REQUEST FOR TECHNICAL REVISION (TR) COVER SHEET

PITCH RECLAMATION PROJECT

RE: 2018 Field Activities to Support Establishment of the Lowest Practical Level for Uranium, Pitch Reclamation Project, Colorado Division of Reclamation, Mining and Safety Reclamation Permit Number M-1977-004

HMC hereby requests a Technical Revision to the Pitch Reclamation Project reclamation permit No. M-77-004HR. The following sections provide facility information, the proposed activities to be conducted in 2018 to support alternatives advancement and design, and information on reclamation of disturbed areas following LPL implementation activities. Additional details associated with former field activities are provided in the 2016 Alternatives Analysis Report, submitted to the Water Quality Control Division, the U.S. Environmental Protection Agency, and DRMS on December 6, 2016 (Arcadis 2016).

FIGURE
2

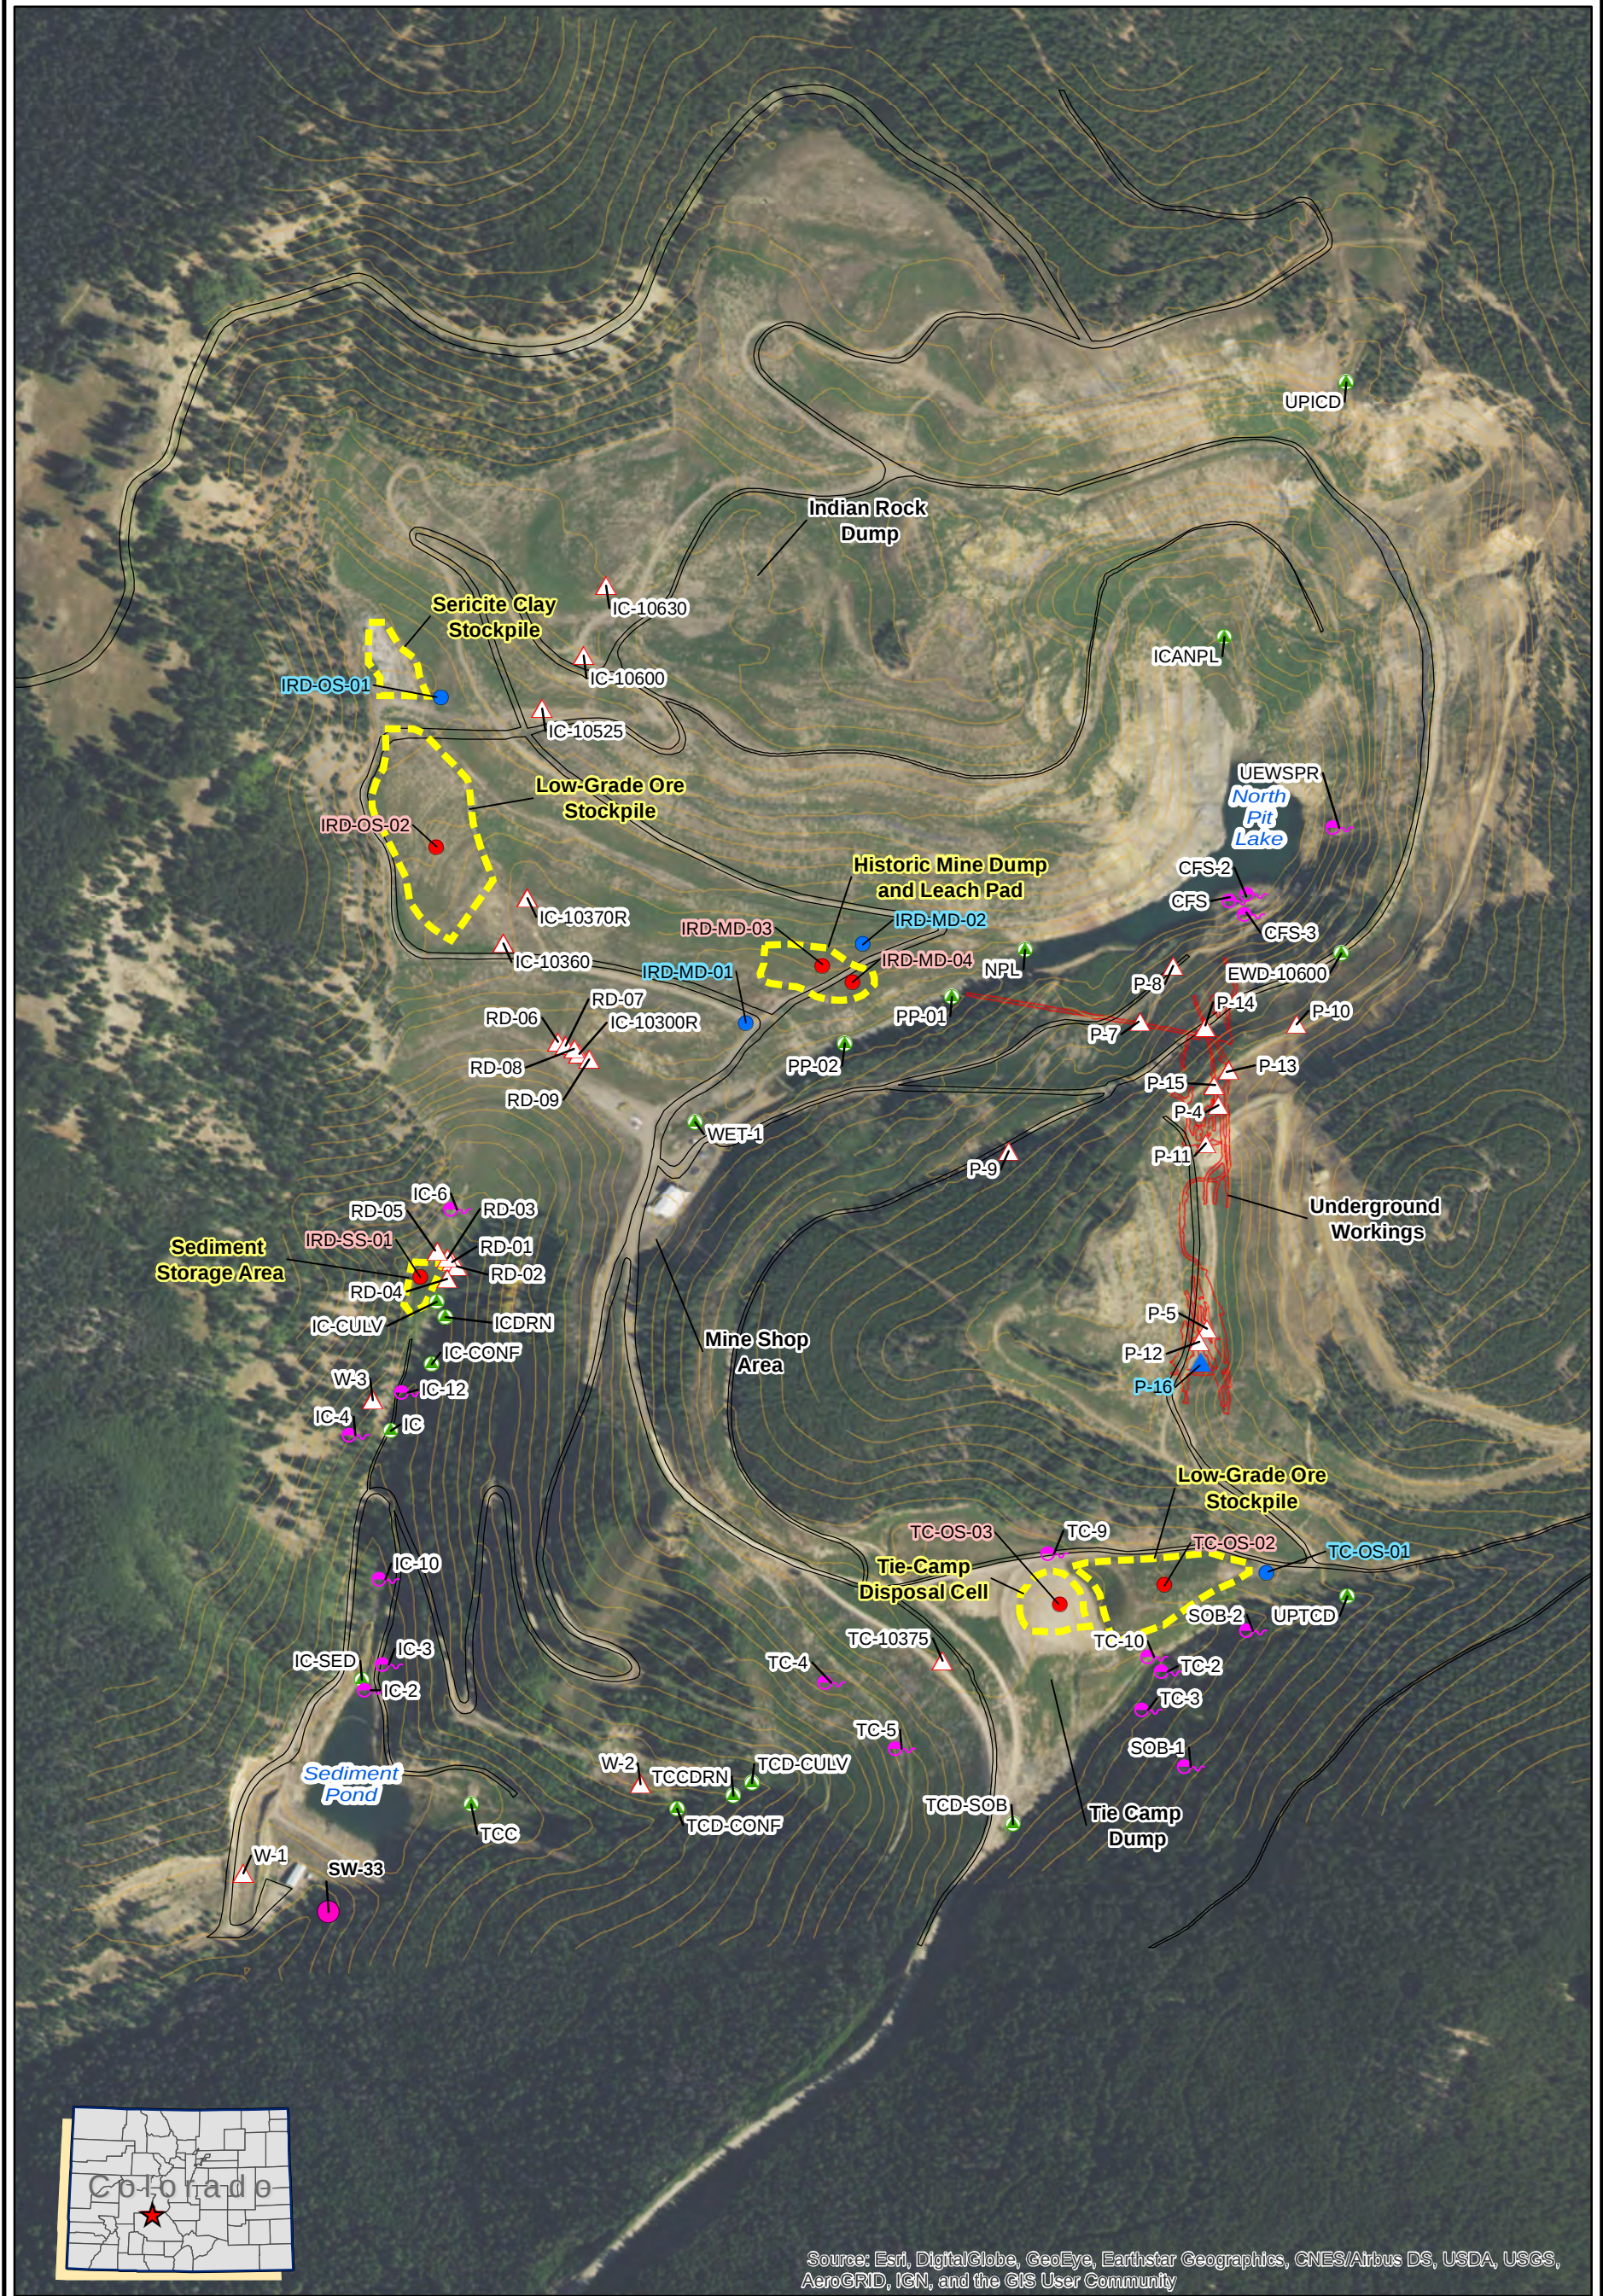
- Installation of one reagent injection/recirculation/monitoring well in or near the underground mine workings (**Figures 2 and 3**).
- Installation of up to ten boreholes/piezometers in the Indian and Tie Camp rock dumps for characterization of potential localized uranium source zones (including two low-grade ore stockpiles, the former leach pad/mine dump area, and the

- Installation of fencing around injection well infrastructure at the top of the Indian Rock Dump (**Figure 2**).

- High-density polyethylene (HDPE) plastic piping associated with water conveyance and electrical conduits at the underground mine workings phosphate injection system will be extended to run to wells P-5, P-12, and P-16 (**Figure 2**). Installation will be performed in a manner consistent with pipe installation conducted in 2017. Specifically:
 - o Piping running along access roads and on steep grades will be maintained aboveground, secured to the ground using stakes and wire harness.
 - o Piping will be buried or transmitted through an installed culvert at locations where piping crosses existing access roads.
 - o Piping running parallel to access roads and/or drainage ditches will either be secured adjacent to the roads/ditches or placed into the drainage and away from roadways for safety purposes.
 - o Piping will be HDPE welded, flanged, or a combination.
